TOWN OF BAY HARBOR ISLANDS PLANNING AND ZONING BOARD

September 5, 2017

FINAL AGENDA

MMPA recommends the Planning and Zoning Board review the contents of this staff report, the latest revised site plan and architectural plans (dated 06/29/17) and if felt to be acceptable, **APPROVE** the plans as submitted or with modifications as deemed appropriate and/or with conditions, to allow for the construction of additions/renovations to a single-family home located at 9555 Broadview Terrace.

3 PROPOSED FIRST FLOOR PLAN
SCALE: 1/4" = 1'-0"

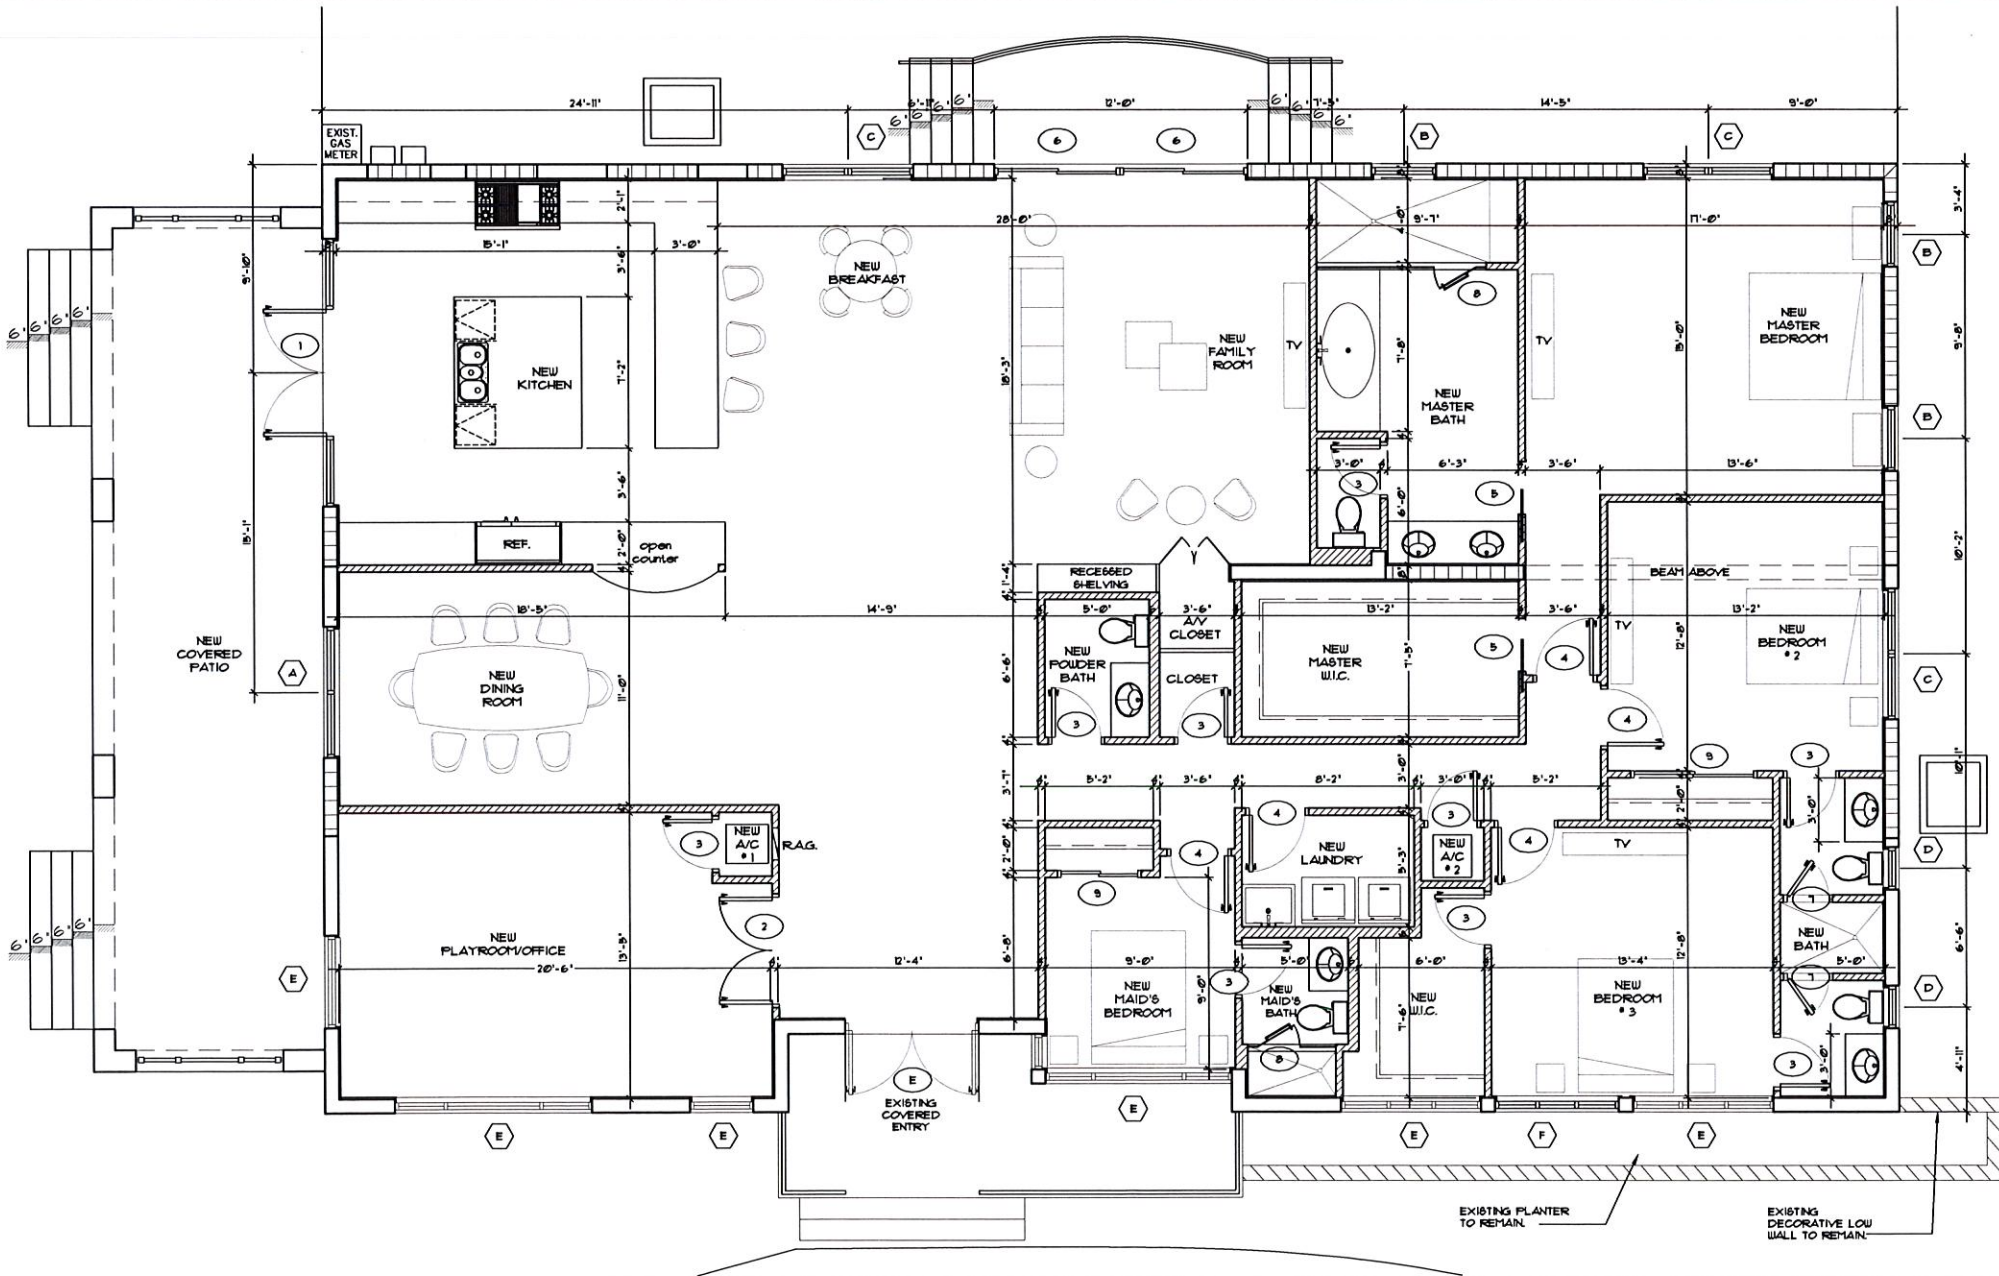
It should be noted that there will be no solid fence in this renovation along the north side of the property (along Kane Concourse), only a dense hedge. The previous plans included a fence / wall.
